ITEM: 6.1	REPORT SUMMARY MINOR VARIANCE APPLICATION FILE NUMBER A136/23
------------------	--

MINOR VARIANCE APPLICATION FILE NUMBER A136/23

CITY WARD #:	2
APPLICANT:	Luigi Maffeo & Consolata Maffeo
AGENT:	Luigi Maffeo
PROPERTY:	69 Kingly Crest Way, Woodbridge
ZONING DESIGNATION:	See below.
VAUGHAN OFFICIAL PLAN (2010) DESIGNATION:	Vaughan Official Plan 2010 ('VOP 2010'): "Low-Rise Residential"
RELATED DEVELOPMENT APPLICATIONS:	None
PURPOSE OF APPLICATION:	Relief from the Zoning By-law is being requested to permit a covered shed, including roof overhang.

SCHEDULE A: DRAWINGS & PLANS

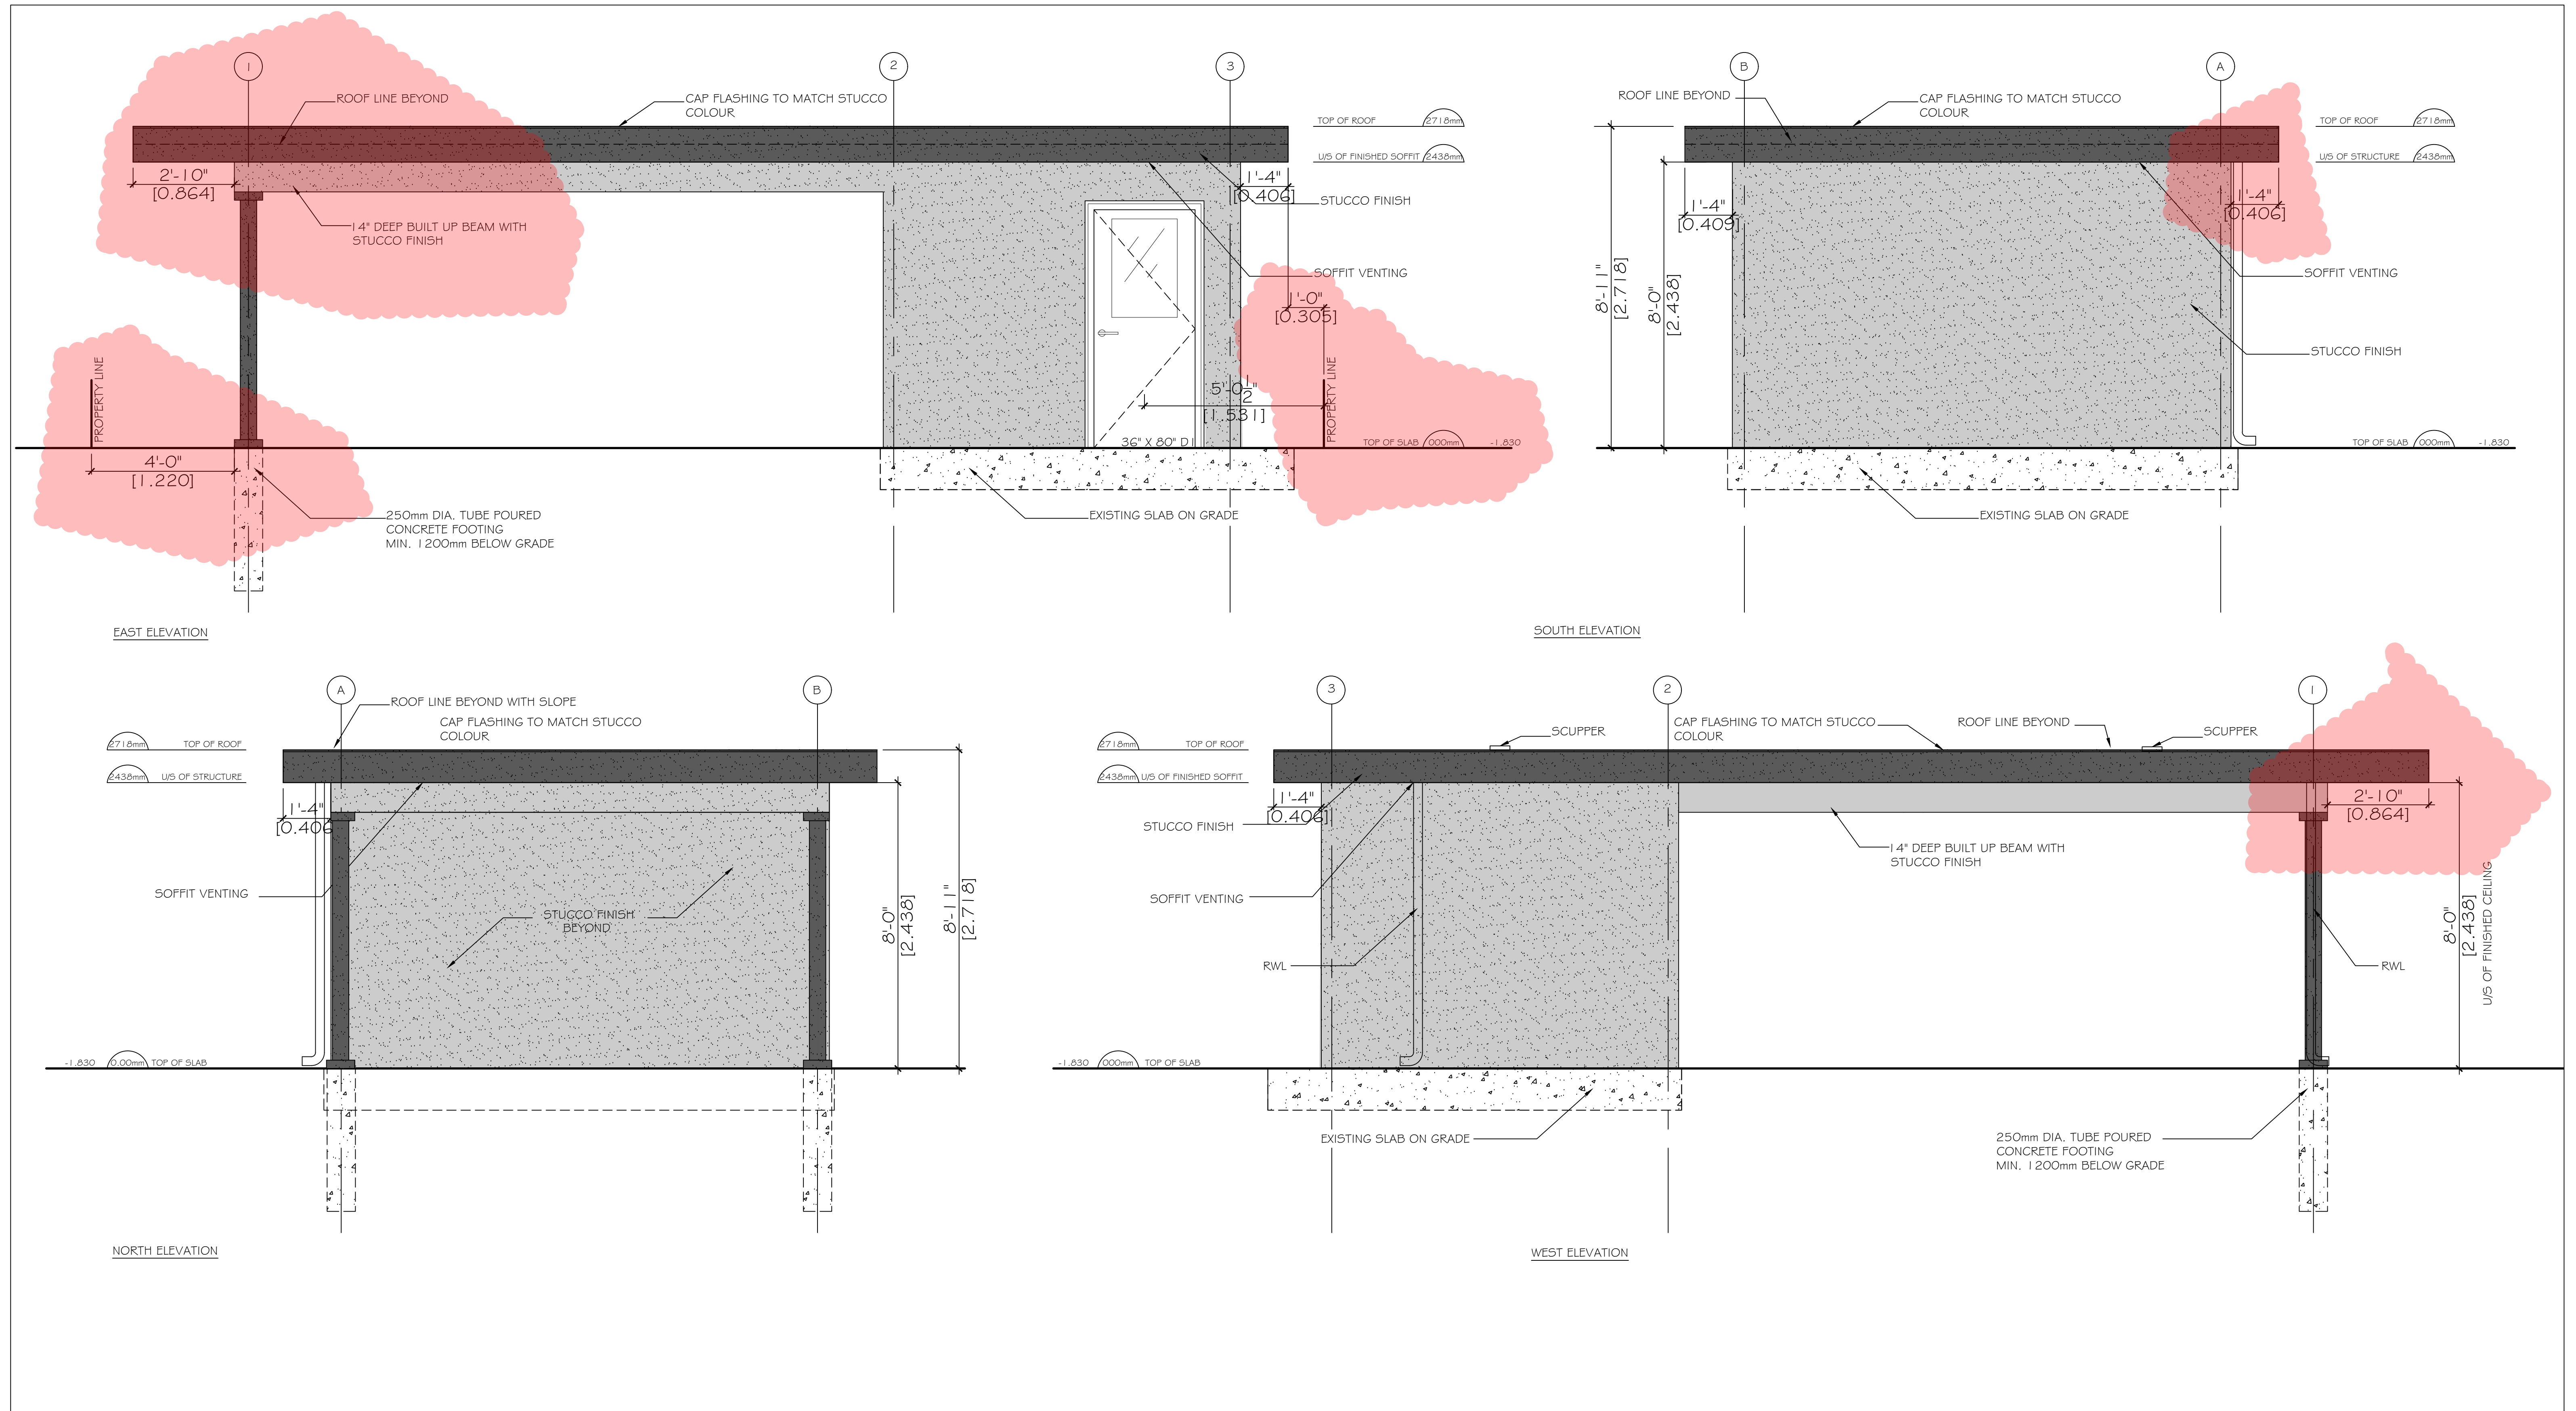
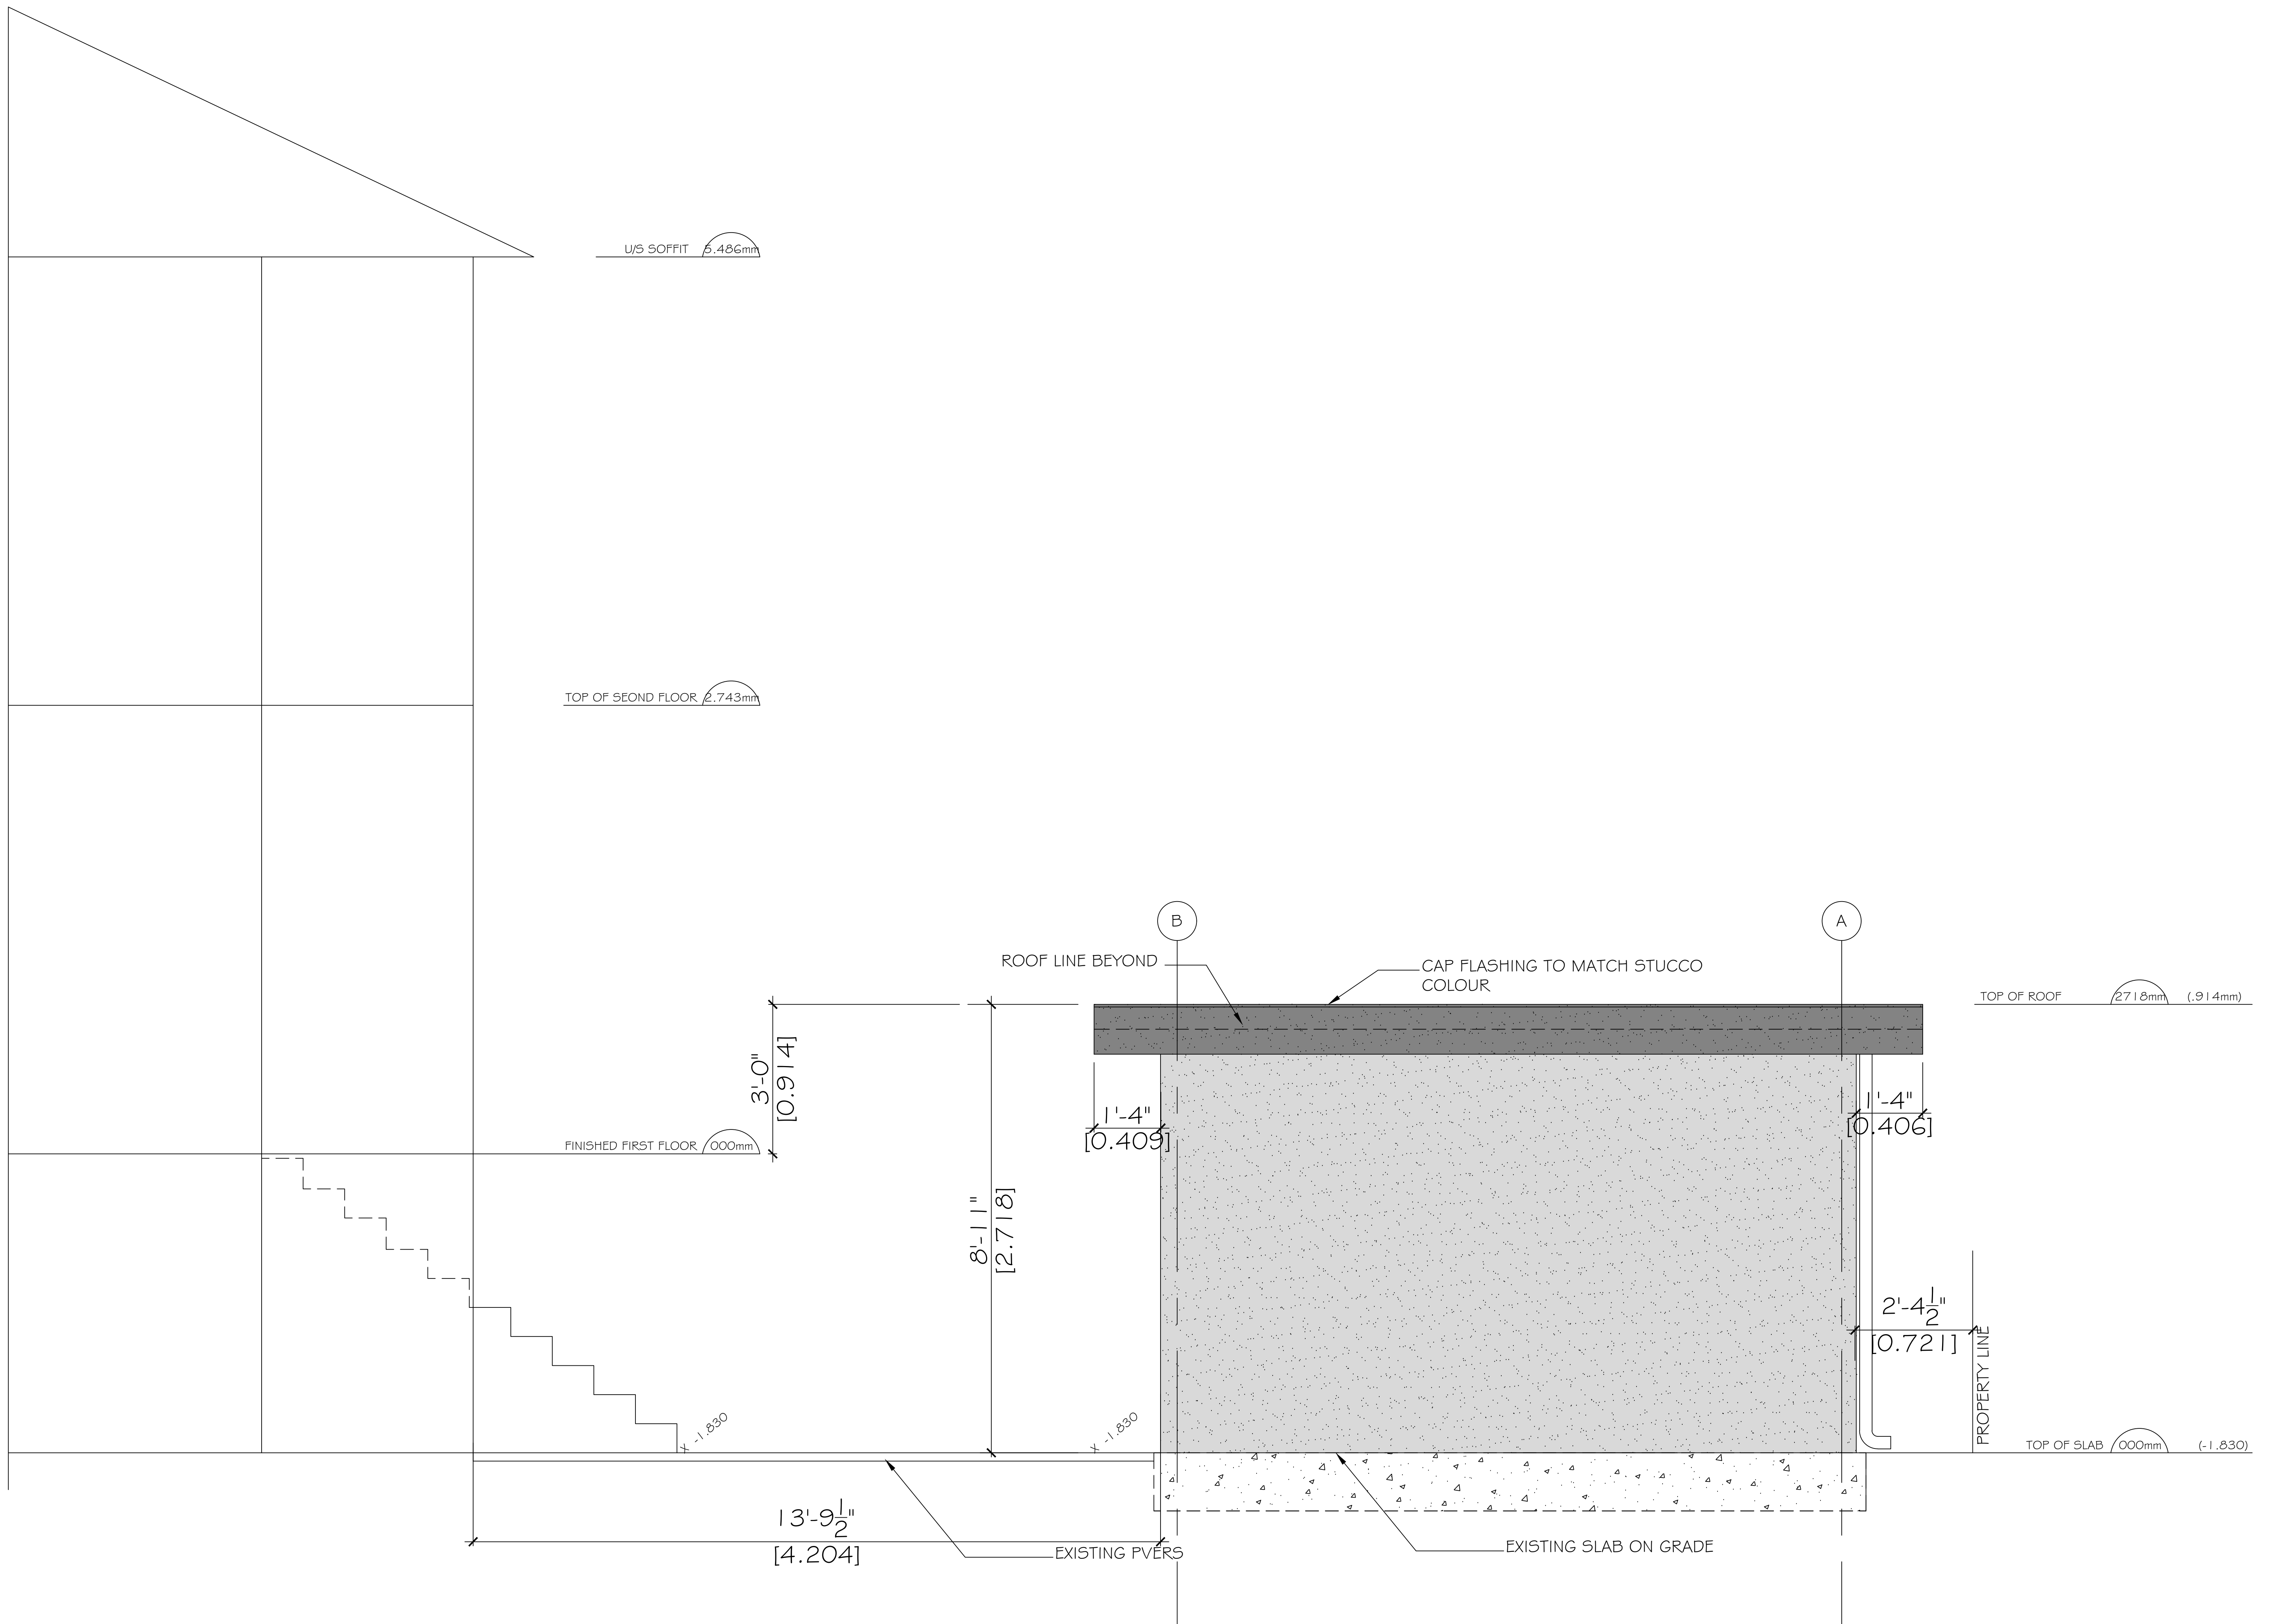
The Development Planning Department is not in a position to support Variances 1, 3, and 4 for the reduced rear and interior side yard setbacks to the accessory structure. The structure has a flat roof design and contains an enclosed storage room along with a covered outdoor lounge area. The 9.75 m length of the structure, inclusive of eaves, occupies about 94% of the rear yard's 10.4 m width. The rear yard of the subject property abuts neighbouring rear yards to the north and south and an interior side yard to the east. The structure's length relative to the length of the rear lot line, in combination with its proximity to the side and rear lot lines and its overall footprint results in a significant amount of massing and privacy impacts.

The structure, in its existing state, occupies most of the rear yard. The rear yard depth (without the structure) is measured at 9.49 m from the dwelling to the rear lot line. The structure, inclusive of eaves, is set back approximately 4.1 m from the dwelling (occupying approximately 54% of the rear yard's depth) and as previously mentioned above, it spans about 94% of the rear yard's width. Based upon this analysis, it is concluded that the structure occupies a significant portion of the rear yard. Due to its size and prominence, the existing structure generates substantial mass within the rear yard, impacting the overall function of the rear yard as a landscaped outdoor amenity space. A function of a rear yard is to provide sufficient outdoor landscaped space (hard and vegetative surface) to provide open air amenity and recreational opportunities. It is anticipated that a structure of such scale will also generate use impacts greater than a structure of a smaller size. These more intensive uses also cannot be adequately buffered for reasons identified above. It is Staff's opinion that this structure impedes the functionality of the rear yard. Given the lack of buffering and proximity to the abutting yards, adverse massing and privacy impacts are anticipated to the abutting rear yards to the north and south and the abutting side yard to the east.

Therefore, for Variances 1, 3, and 4, it is staff's opinion that permitting a structure of this scale where only a 0.71 m interior side yard setback remains, with the additional encroachment of the eaves of the structure on 3 sides, is a substantial deviation from the zoning by-law's intent, is not minor in nature, nor desirable and appropriate for the use of the land.

The Development Planning Department is not in position to support Variance 2 to permit a maximum lot coverage of 14%. Urban Design staff reviewed the proposal and are of the opinion that the existing structure is too close to the three abutting neighbours and that unsuitable space is provided to accommodate any vegetative screening. Both Development Planning and Urban Design staff agree that the structure cannot be supported in its existing state. A function of accessory structure lot coverage is to maintain a modest (i.e., accessory) scale in relation to the dwelling and yard. As identified in the analysis above, the structure occupies a majority of the rear yard and as such, it becomes a primary building due to its visual prominence. The rear yards of the lots along the east side of Kingly Crest Way are all similar depths and contain sheds of modest size. There are no nearby structures the size or mass of the existing structure and there is no vegetation present on the subject property or neighbouring properties to mitigate the potential adverse impacts the structure poses on not just the properties within the immediate context, but on properties further to the north and the streetscape to the south (Royal Pine Avenue).

The Development Planning Department recommends **refusal** of the application.
